R. E. GINNA NUCLEAR POWER PLANT

Amendment No. 11
License No. DPR-18

ATTACHMENT TO LICENSE AMENDMENT NO. 11
PROVISIONAL OPERATING LICENSE NO. DPR-18
DOCKET NO. 50-244

SAFETY EVALUATION AND ENVIRONMENTAL IMPACT APPRAISAL
BY THE OFFICE OF NUCLEAR REACTOR REGULATION

Figure 3.11-1

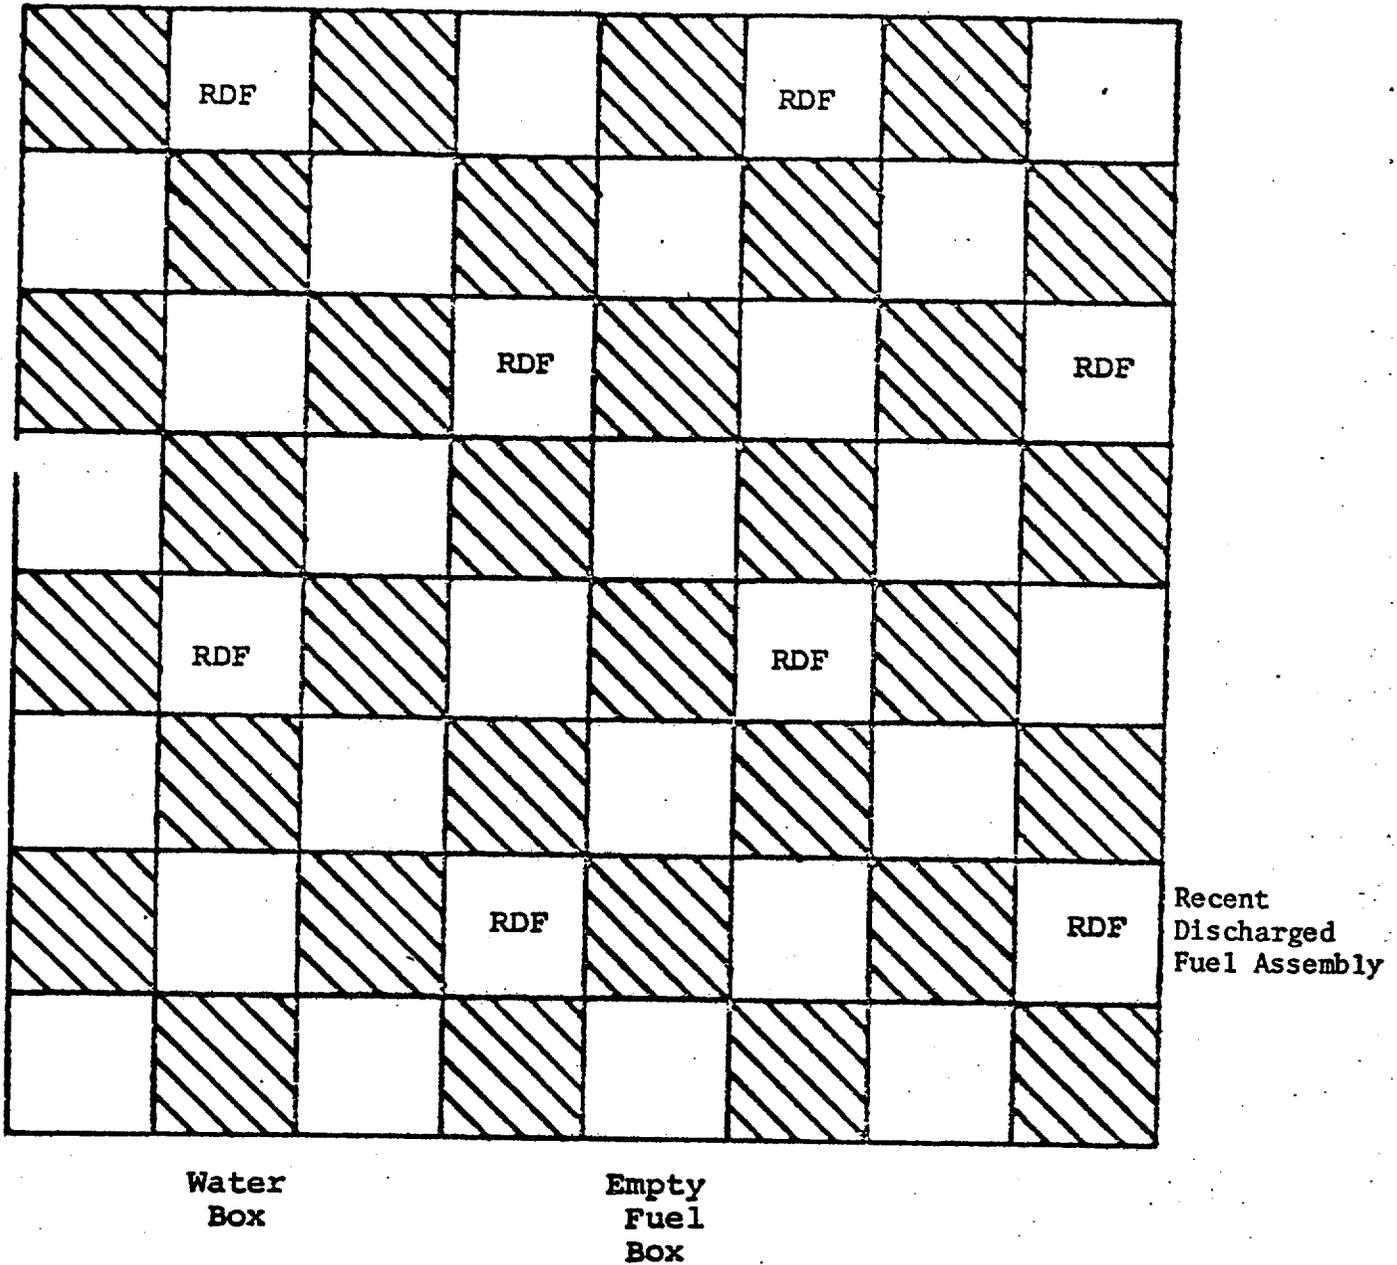
3.11.4 Fuel assemblies with less than 60 days since irradiation shall not be placed in storage positions with less spacing between them than that indicated in Figure 3.11-1 by the designation RDF.

The minimum spacing specified for fuel assemblies with less than 60 days decay is based on maintaining the potential release of fission products that could occur should an object fall on and damage stored fuel to less than that which could have occurred with fuel stored in the original fuel storage racks.
